Building Permit Application

RE: **1031 Stepping Place**, Potential Basement Bedroom

I have reviewed the floor plans in support of Building Permit **B19001811** for a new home at **1031 Stepping Place** and noted that there is a full bathroom in the partially finished basement. Please note that this makes it very likely for one or more rooms to be considered bedrooms upon redesign of the finished basement area or conversion of the unfinished basement area to living space.

1031 Stepping Place
Lot 10
Walker Meadows

MODEL STRAITFORD HALL	SET NO. 11900	VERSION 01	DRAWN BY BIM	DATE: 5/7/2016	OPTION FBA MAC
DRAWING TITLE BASEMENT FLOOR PLAN PARTIALS					
OPTION DESCRIPTION FULL BASEMENT FINISHED BASEMENT					
SHEET NO. A-6					28

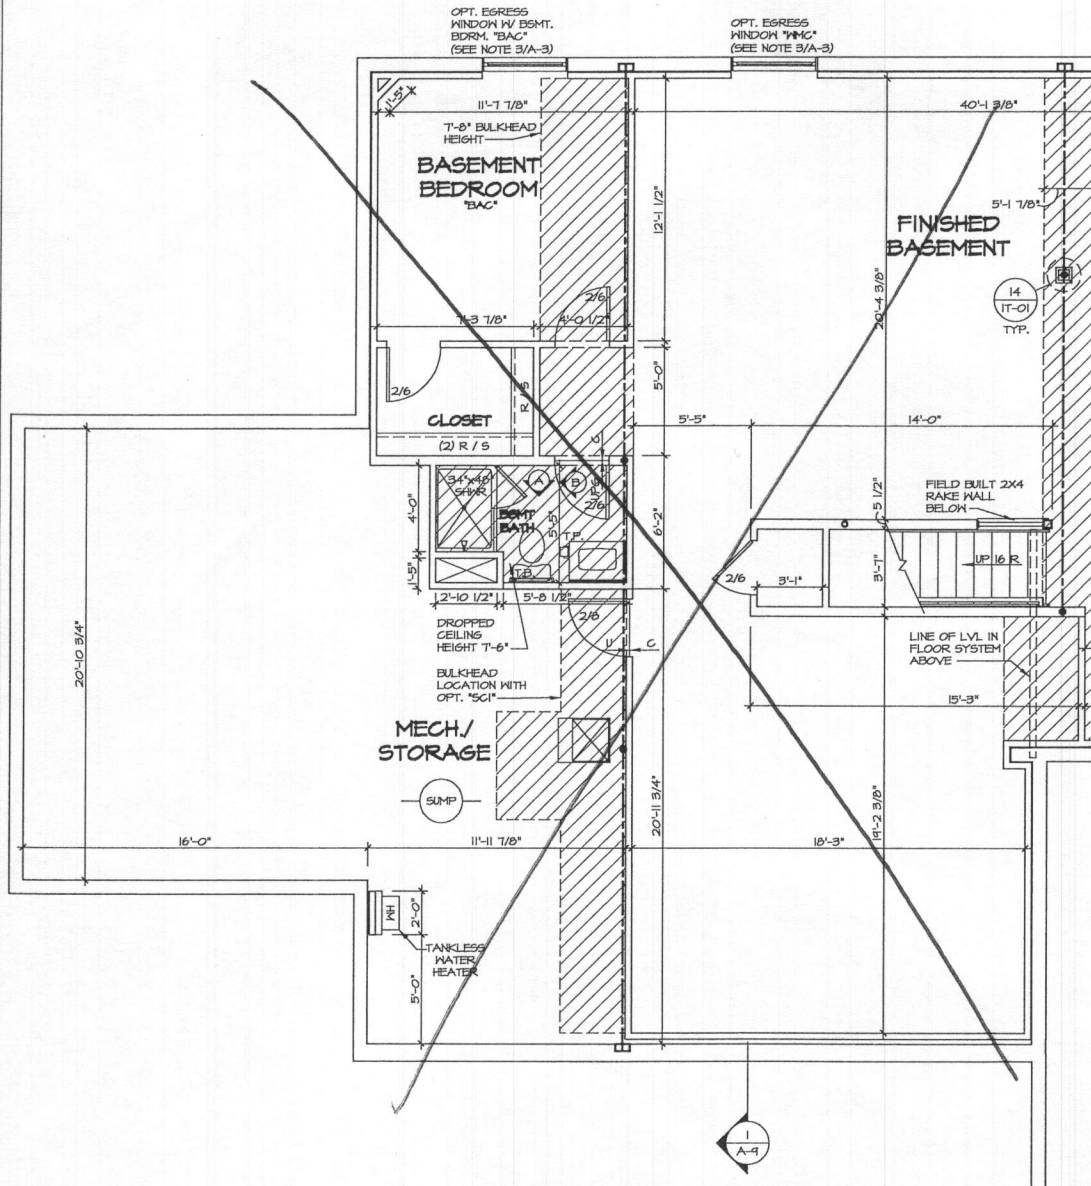
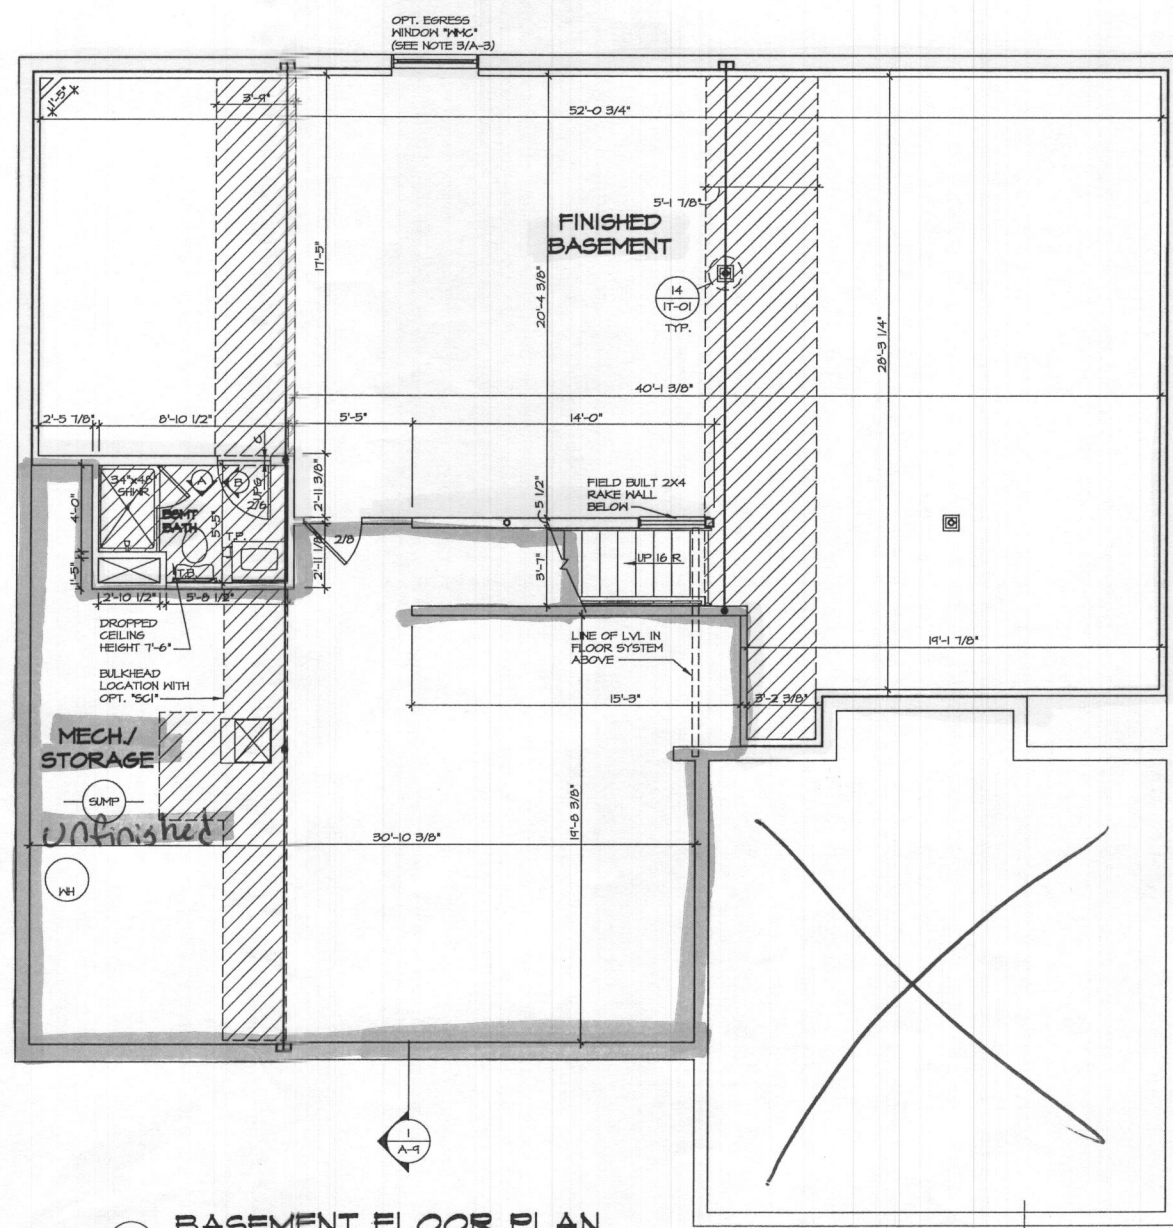
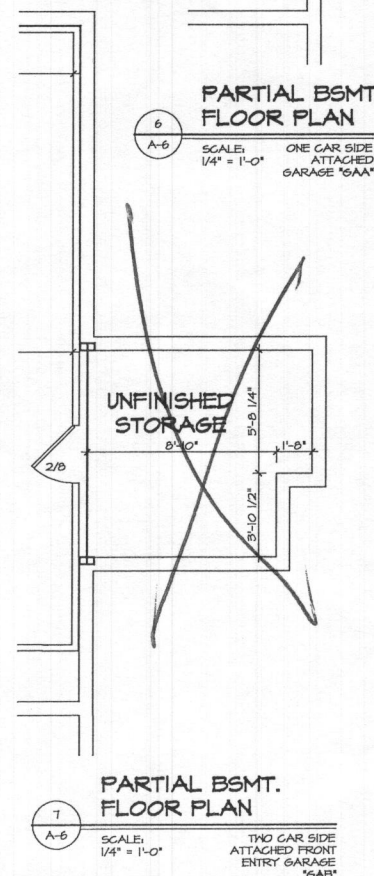
The Health Department strongly recommends sizing the onsite sewage disposal system at least one bedroom larger than the existing **four (4)** bedroom design to accommodate a future finished basement. If you choose to only size for the existing design, any future building permit for a finished basement may be placed on hold until the system is upgraded to accommodate the proposed number of bedrooms. This memo will be retained in the Health Department file for future reference.

REVISED
 Date: 7/8/19
 Comments: B19001811
 REVISED SEPTIC TANK
 + TRENCHES
 LOT 10
 BUILDING PERMIT PLOT PLAN

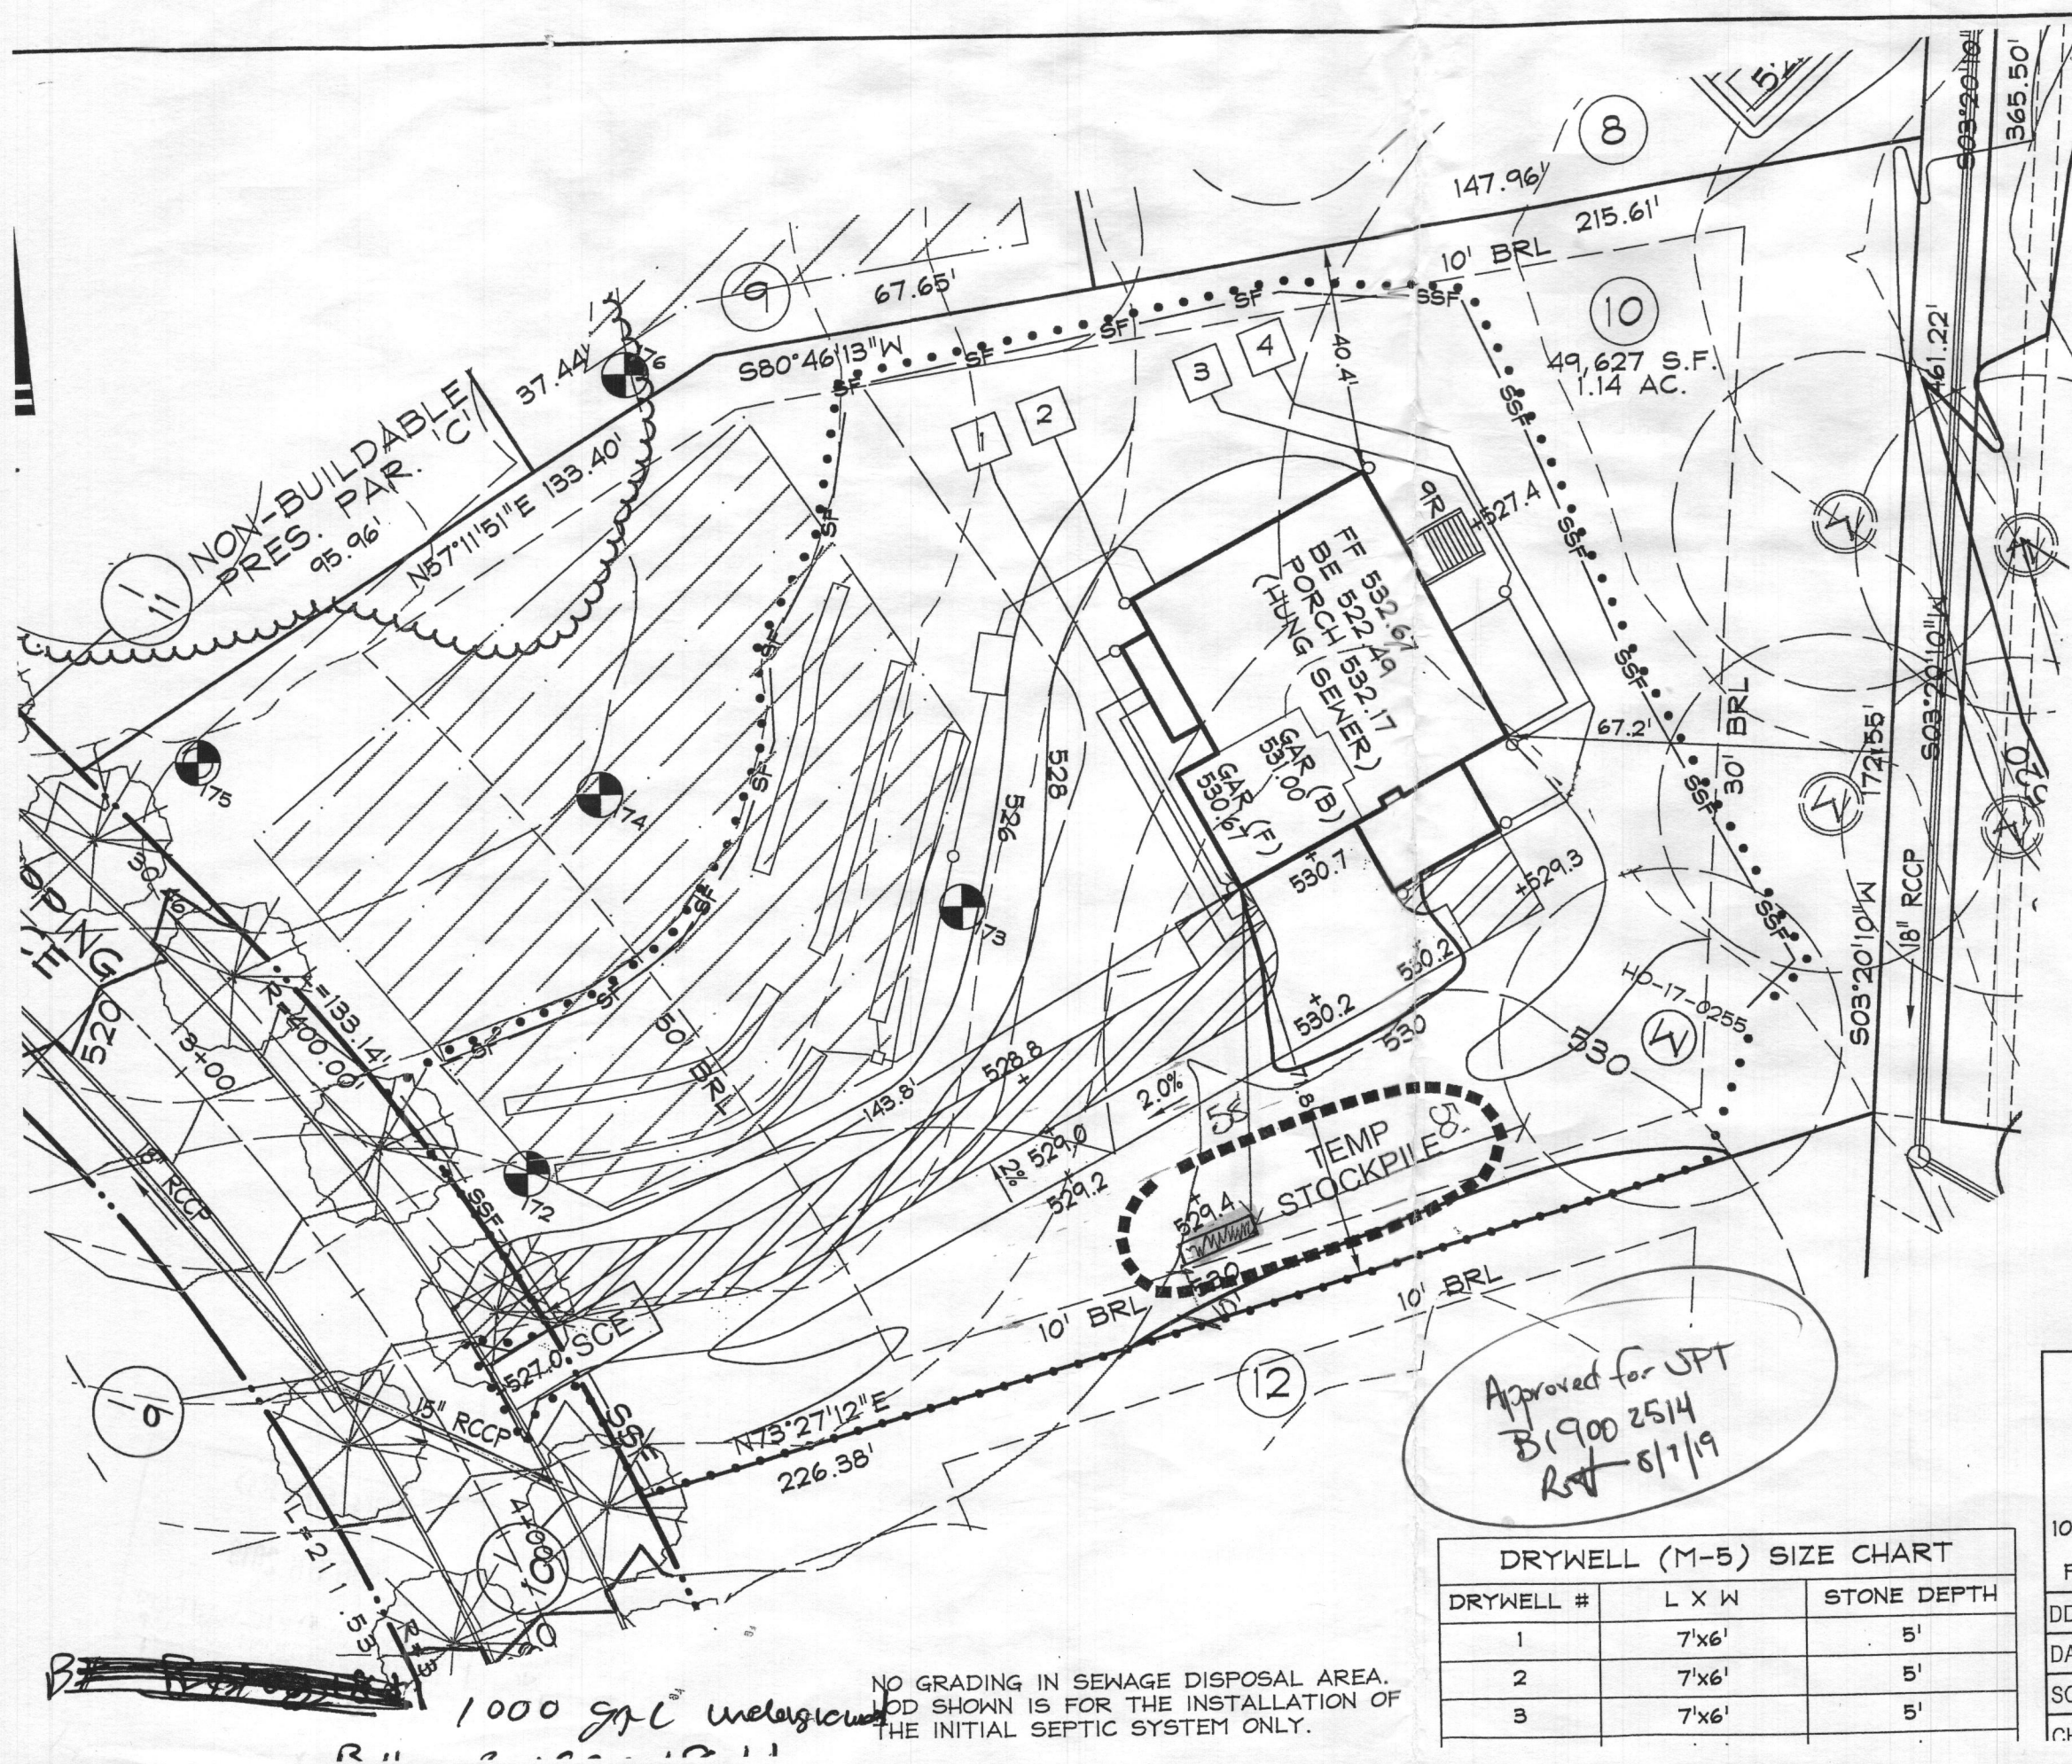
REVISED SEPTIC TANK
+ TRENCHES (PER HEALTH)

Approved Septic System Plan
 Howard County Health Department
 1st bedroom SFD
 approved as illustrated
